## Ordinary Meeting

CL25.413	Development Application DA2024/1589 - 737 Woollamia Road WOOLLAMIA - Lot 12 DP 9289	
Attachment 1	Architectural Plan Set.....	2
Attachment 2	Draft Notice of Determination - Refusal .....	13
Attachment 3	S4.15 Assessment Report.....	17
Attachment 4	Covering Letter RFI Response .....	92
Attachment 5	Response to SCC.....	95
Attachment 6	Suitability of Material or Construction Methods Report .....	107
Attachment 7	Flood Risk Management Peer Review.....	110
Attachment 8	Flood Affection Report.....	122
Attachment 9	Emergency and Evacuation Plan.....	125
Attachment 10	Flood Evacuation Map.....	129
Attachment 11	Hydraulic Model Results.....	131
Attachment 12	Acid Sulphate Soils Management Plan .....	166
Attachment 13	Livable Housing Assessment Report.....	175
Attachment 14	Arborist Impact Assessment.....	190
Attachment 15	Bushfire Assessment Report .....	209
Attachment 16	Site Plan Rev. D .....	252
Attachment 17	DA3.00 Section Plans.....	253

Proposed Attached Dwellings (3 x 3 Beds) AT 737 WOOLLAMIA RD WOOLLAMIA NSW 2540  
LOT 12 DP 9289

<b>Section 4.15 Assessment Report</b> <i>Environmental Planning &amp; Assessment Act 1979</i>
---	--

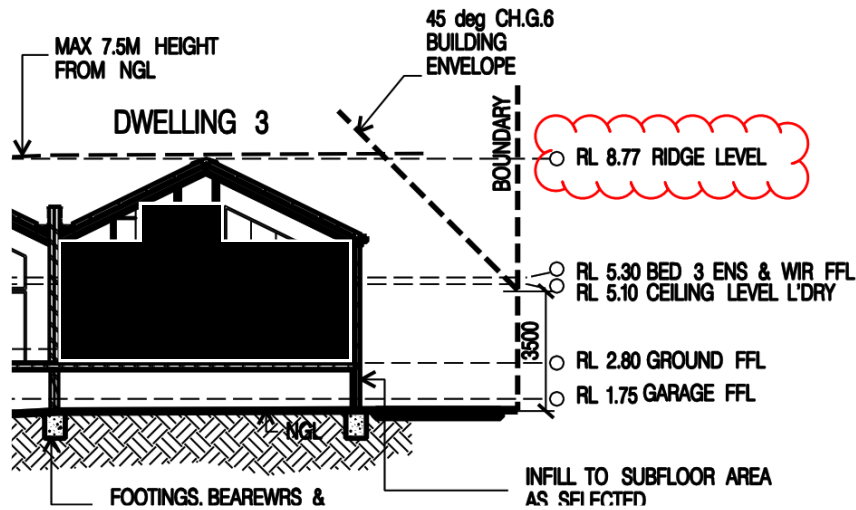
BCA (National Construction Code (NCC)) - The proposed dwellings will be Class 1a and 10a under the BCA. Detailed plans demonstrating compliance with the BCA will need to be submitted with a CC for assessment. A preliminary review of the plans has identified the following potential issues:

- Ceiling of Bedroom 2 on the ground floor – Section A-A of the proposal (D25/443435 - snip below) shows the Ground finished floor level (FFL) of Bed 2 for Dwellings 2 and 3 to be RL 2.80 and the ceiling level of the laundry to be RL 5.10. This is a ceiling height of 2.3 metres which is acceptable for a laundry. However, the Section does appear to show that the laundry and Bed 2 will have the same ceiling height. The minimum ceiling height required in Bed 2 for compliance with the BCA is 2.4 metres. This could be addressed at CC stage by increasing the height of the building, but the proposal appears to be at, or close to, the maximum allowable building height under the planning instruments for these dwellings.

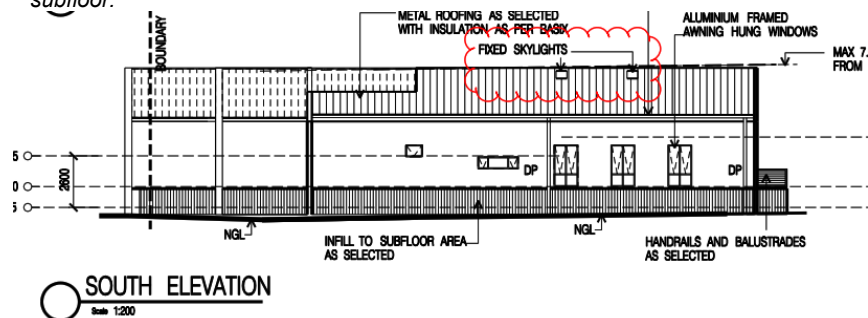
A section through Bed 2 of Dwelling 1 has not been provided. (Resolved)

- Potential subdivision – The Statement of Environmental Effects does not identify a strata or Torrens title subdivision as part of the current proposal. However, it appears from the plans that the applicant is considering a subdivision in the future (e.g. showing a dashed 'boundary' line centrally through the separating walls of the dwellings). From the sections and the southern elevation, it appears that the separating wall between dwellings (i.e., where attached) will be masonry construction, and the extension of the wall towards the front boundary, for example, will be framed construction and clad, with open subfloor.

South elevation – showing external walls of Bed 1 in Dwellings 1 and 2 with open subfloor. Any future subdivision, as suggested on the plans, will create external walls less than 900 mm to a boundary. These walls will need to achieve a minimum Fire Resistance Level (FRL) of 60/60/60 and will need to commence at the footings. For a scenario like the implied subdivision, upgrading work to the walls will be required to comply with the BCA. This would require the elimination of the open subfloor which is likely to impact upon any flood requirements.

*Typical Notes on Plans – framed internal walls proposed.*

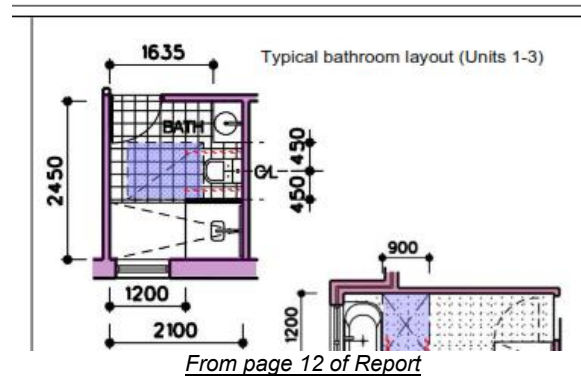
masonry walls. The plans and the detail in the report (reproduced below) appear to show the internal walls as framed construction, not masonry.

**Figure 1 – Critical Duration Hydrographs**

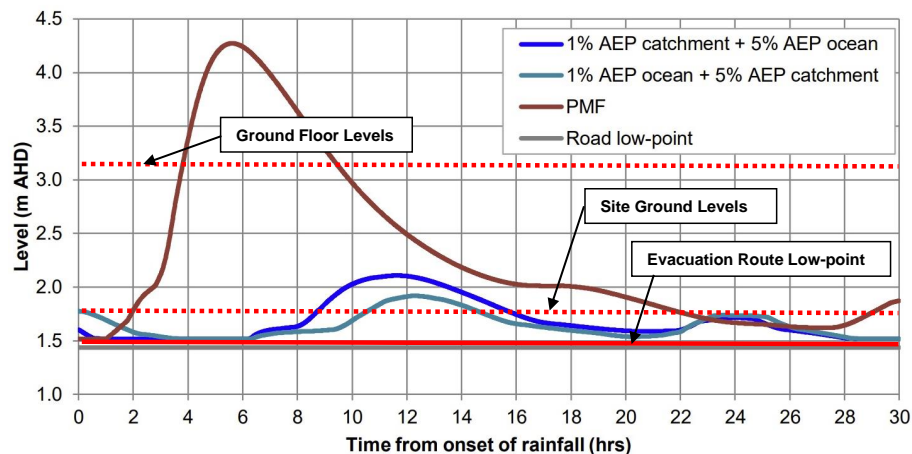
13. As can be seen in **Figure 1** – for the entire duration of a 1% AEP or PMF event, the low-point of the evacuation route is cut (i.e. over 30 hours). This would be reduced in terms of duration for shorter rainfall events, but the surrounding tailwater levels mean a similar isolation period.
14. The worst-case 1% AEP event shows that the site is inundated for approximately 7.5 hours.
15. This raises an important point, which is: even if the land was PMF-free and therefore had no flood affectation or applicable development controls – it is still unable to be evacuated

- a. Inundation of an evacuation route from the site could occur without the instrument being triggered (for example, because of a high tide).
  - b. The rates of rise. The peak rate of rise (in **Figure 1**) is 1 metre per hour, and the difference between the normal water level and the evacuation route being lost is approximately 1 metre. One hour from the instantaneous movement of a water level gauge is not enough time (or enough information) upon which to trigger an evacuation warning.

**Figure 2 – 1% AEP Tide Levels and Durations**

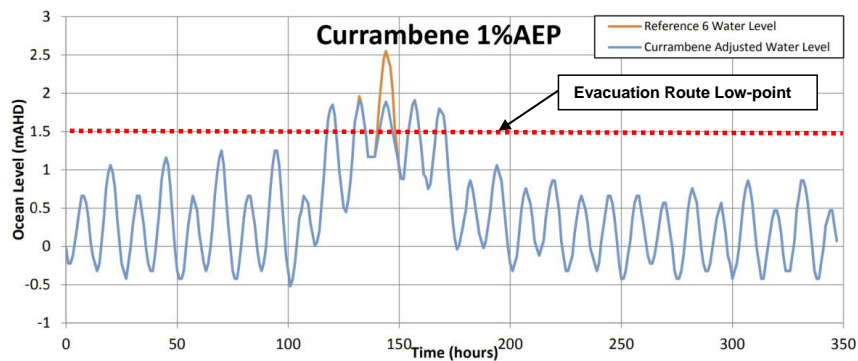
17. It can be seen in **Figure 2** that for a 1% AEP event, there are five times that the evacuation route is cut by tides alone in approximately 2 days – without any consideration of flooding in Currambene Creek. These instances are for greater than 6 hours.
